STAFF REPORT

APPLICATION NUMBER FDP 78-P-130-2

PROVIDENCE DISTRICT

# FINAL DEVELOPMENT PLAN

FDP 78-P-130-2

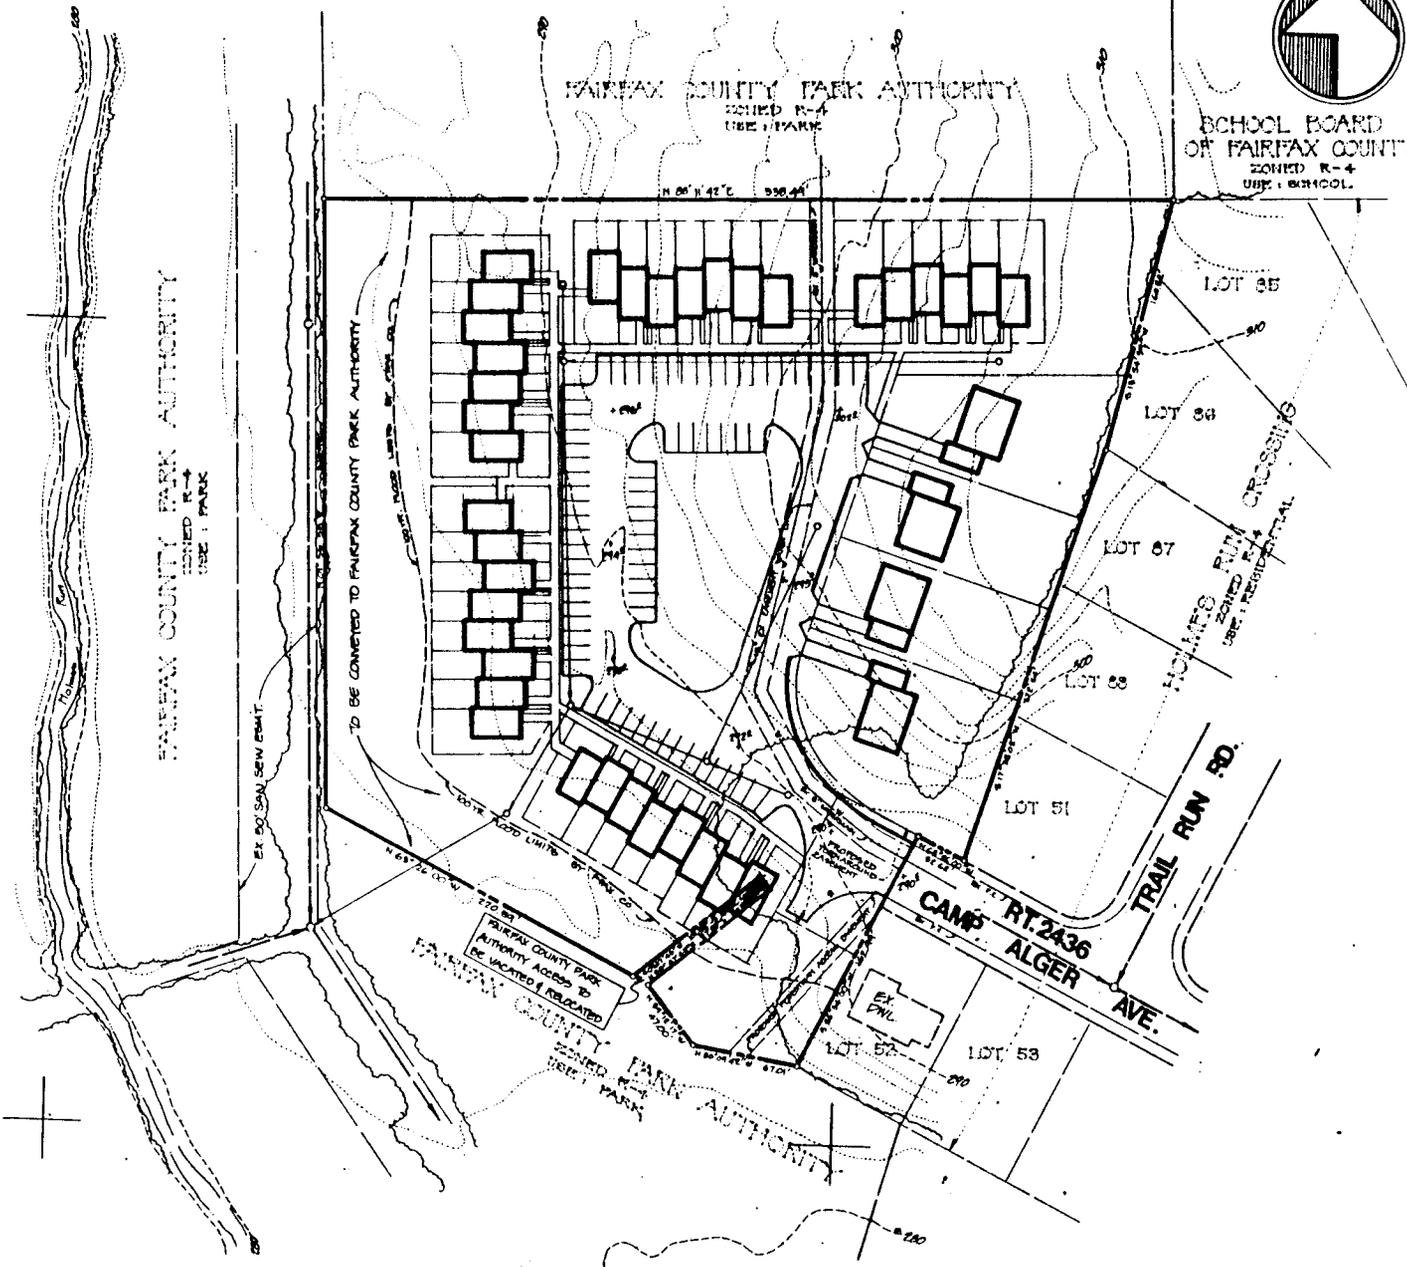
- o A failure to specify the type of trail to be constructed along the floodplain. The Park Authority recommendations with regard to this matter appear at Appendix 5. The construction standard which they recommend should be required.

- o The provision of a pedestrian/bicycle trail between the two rows of townhouses on the north of the site raises grave concerns as to the compatibility of the facility with the residential use. If the trail facility were to be constructed as recommended by the Park Authority, it would likely function to attract off-site traffic to and from the recreation center. Should the trail be constructed as a four-foot wide asphalt facility it would likely be compatible with the residential use because it would not be as attractive. In summary, though it is essential that a trail facility be provided for this development's access to the recreation center, attraction of neighborhood traffic between the proposed dwellings would adversely affect their habitability. Lastly, this trail suggested by the Park Authority would not be the only means of bicycle access to the recreation center from Camp Alger Avenue. Access to the recreation center could be gained via the second trail on the site which would be located along the stream valley.

- o No provision is made for the establishment of any limits of clearing along the eastern boundary of the property. If possible, the preservation of existing vegetation would enhance the development proposal.

1. That portion of the Holmes Run 100-year floodplain shown on the Final Development Plan will be dedicated to the Fairfax County Park Authority.
2. All trails and easements proposed will conform with the guidelines set forth by the Fairfax County Park Authority in their memo dated September 23, 1982 with the exception that the proposed trail between the townhouses should not exceed four (4) feet in width.
3. The transfer of the approximately 650 square foot access pipestem from the Fairfax County Park Authority to the applicant/owner.
4. No clearing of trees will be permitted along the eastern portion of the site except for those areas within 20 feet around proposed structures.

ATTACHMENT: Reduced Plat

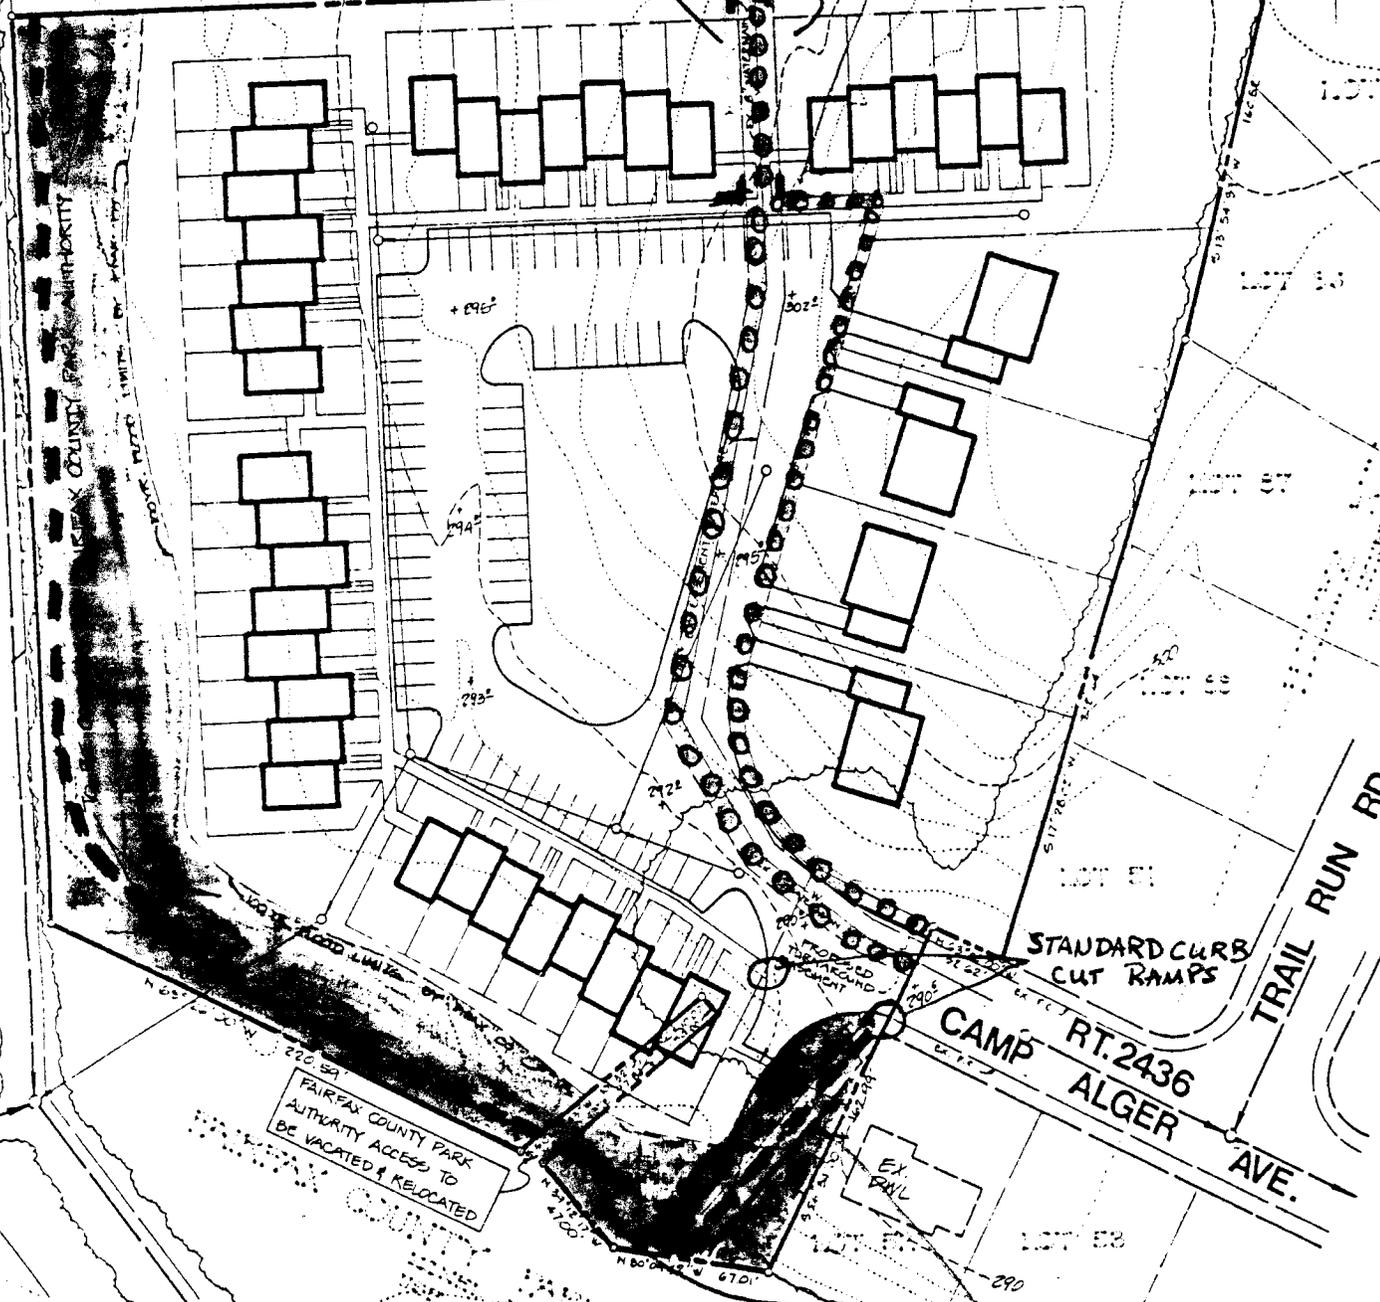
- That the portion of the Holmes Run 100 year floodplain shown on the attached plat reduction be conveyed to the Fairfax County Park Authority and not the Board of Supervisors, as originally proffered, since it adjoins existing FCPA Holmes Run Stream Valley holdings to the South, West and North.

- That the Developer should provide an 8'-0" wide concrete sidewalk from parking lot to property line as access to the adjacent park. A standard concrete curb-cut ramp should be provided and one stall of the proposed parking eliminated or moved to permit unrestricted trail access out to parking lot. The area directly in front of the trail access should be painted and signed as "NO PARKING".

- That a barricade should be provided at the property line to restrict unauthorized vehicular access. Design of barricade by Fairfax County Park Authority Trail Planner.

- That, since the Developer will provide public access easements, a trail and dedication of the floodplain to the Fairfax County Park Authority, the Authority approve the transfer of approximately 650 square feet from FCPA holdings to the Rezoning Applicant, provided that all costs incurred are at the expense of the Applicant.
